Corridor Cities Transitway Briefing

Completed: 01/21/2016

Review of CCT Preliminary Engineering Plans (approximately 30% design level)

Summary of Staff Comments on CCT 30% Design Plans for Forwarding to MTA and MCDOT

Figure 25 – CCT (Approximate) Alignment Comparison – MTA 30% Plan vs. Master Plan Alignment

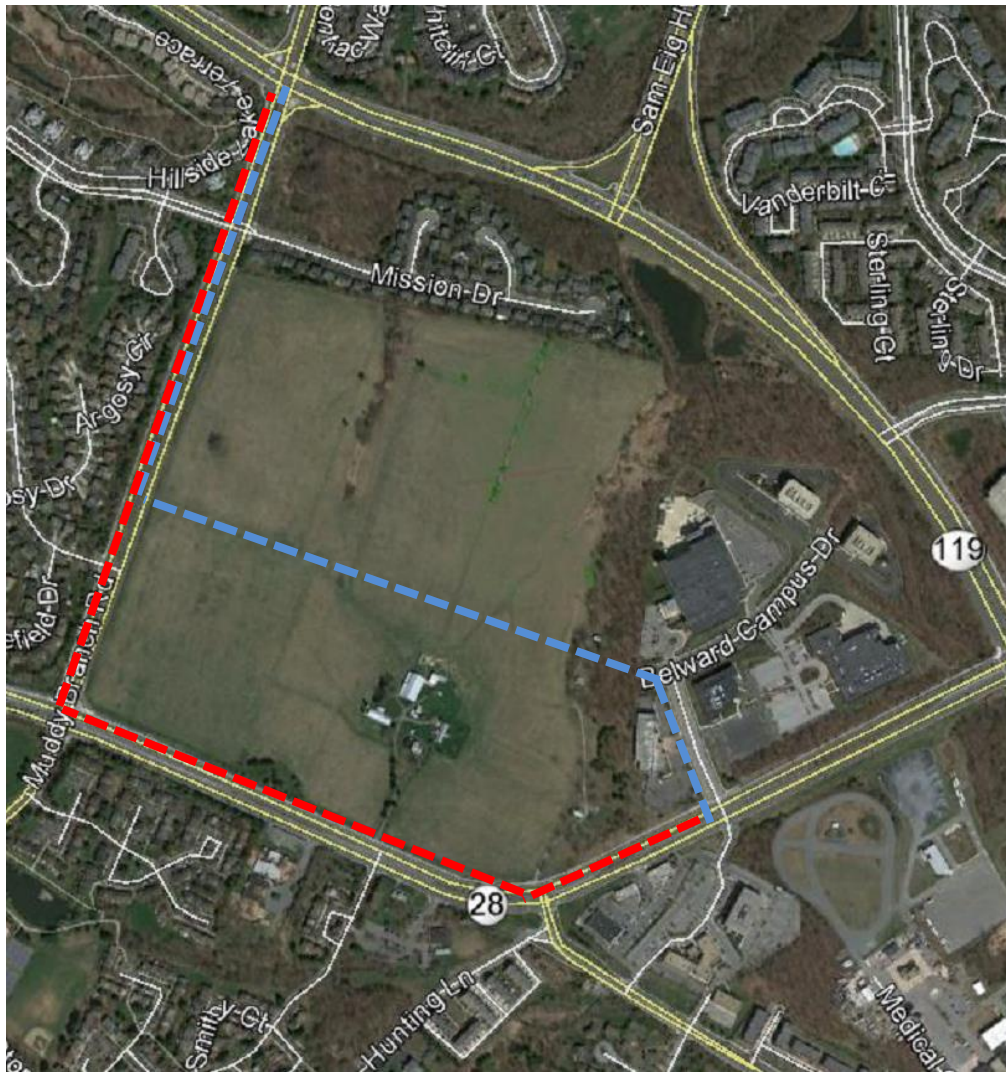
In addition to a need to more closely examine potential alternatives to the interchange at this location (as well as how any interchange would relate to CCT final design), there is a related need to at the same time to examine whether it is feasible to forego plans for the widening of Muddy Branch Road to six lanes. Muddy Branch Road with either four or six lanes will still have four signalized intersections from Darnestown Road to Great Seneca Highway (a distance of about 2,800 feet) with separate CCT signal phases. The potential increase in capacity resulting from the addition of the travel lanes needs to be considered in the context of the setting and the location and function of the signals along the roadway segment. **As a result, staff recommends that as CCT Final Design consistent with the GSSC master plan alignment progresses, additional analysis consistent with that called for in the GSSC Master Plan be carried out that examines the need, feasibility, and compatibility of the interchange and road widening along Muddy Branch Road.**

- 9. CCT Final Design consistent with the GSSC master plan alignment should include additional analysis consistent with that called for in the GSSC Master Plan that examines the need, feasibility, and compatibility of the Great Seneca Highway/Muddy Branch Road interchange and road widening (to six lanes) along Muddy Branch Road.**

Figure 38 – Example of Protected Intersection

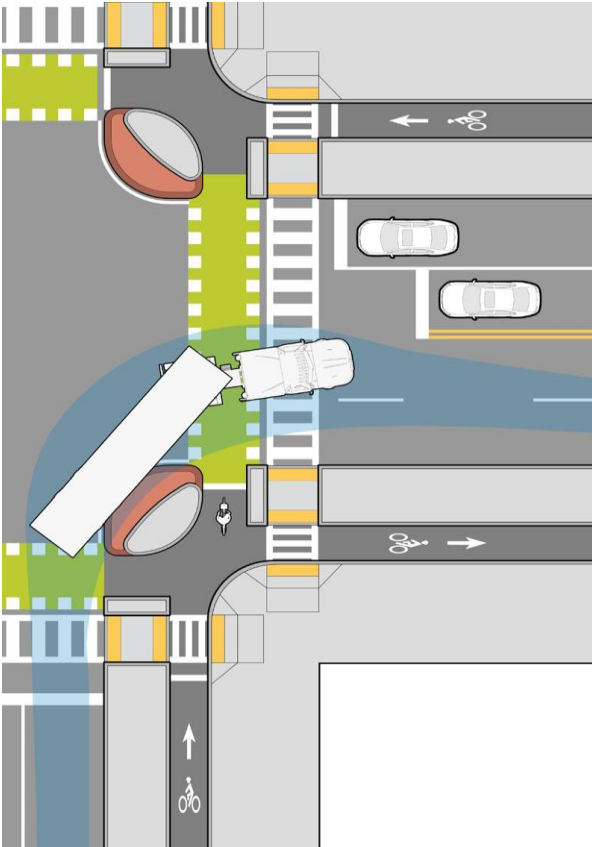
As previously noted, work is underway on the County Bicycle Master Plan. One key design element under consideration is advancing the concept of “protected intersections” that have the potential for providing more efficient separation among pedestrians, cyclists, and vehicles. **Staff recommends that the MTA design team consider the protected intersection design where appropriate throughout the corridor.** A prototype design is depicted below in Figure 38.

- 11. The MTA design team should consider the protected intersection design where appropriate throughout the corridor.**
